HPSII Phosphate Mine

Alachua County Concerns

New River Corridor

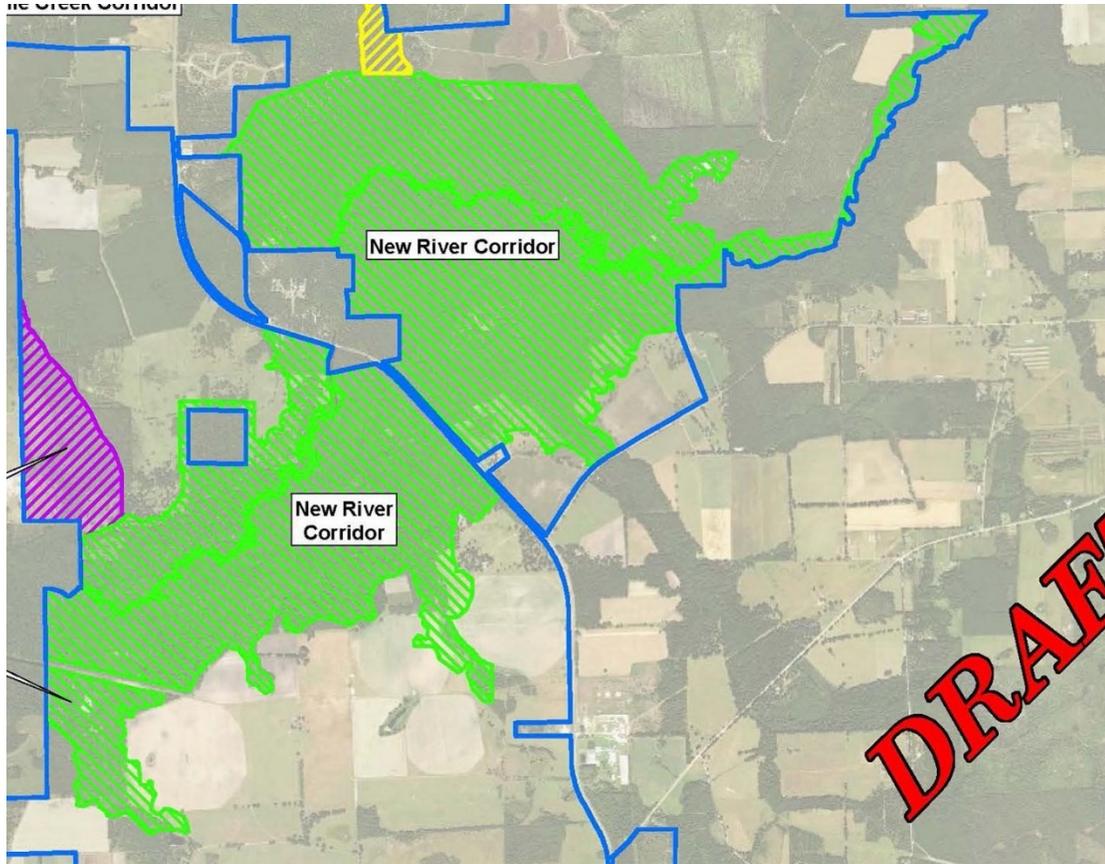
- Monitoring planned for 5 miles of New River within project area only
- NRC limited to river channel in places, especially to northeast
- Fill .38 acre cattle pond on floodplain without cause
- Berm removal at Five Mile Creek entry and another stream to encourage sheet flow

Richard Creek Corridor

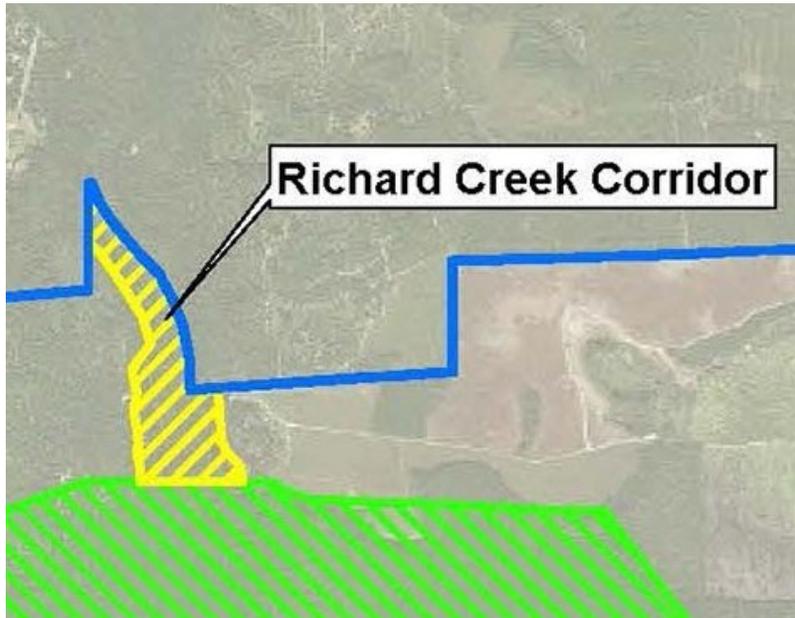
- Northern portion perennial flow
- Southern portion loss of defined channel: a slough to New River
- No upland buffer along eastern stream bank

Five Mile Creek Corridor

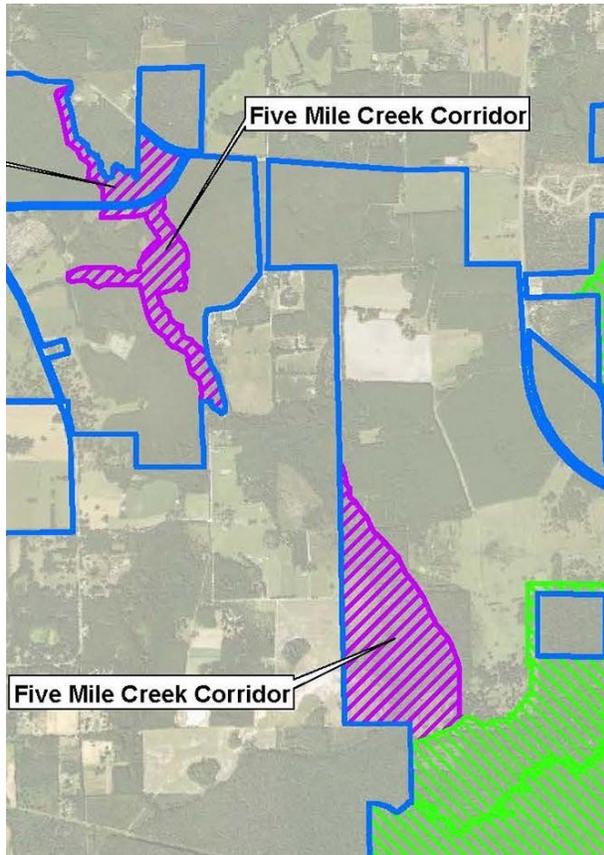
- North and South stream sections not connected with mitigation
- Little upland buffer zone
- Berm removal at boundary with New River Corridor
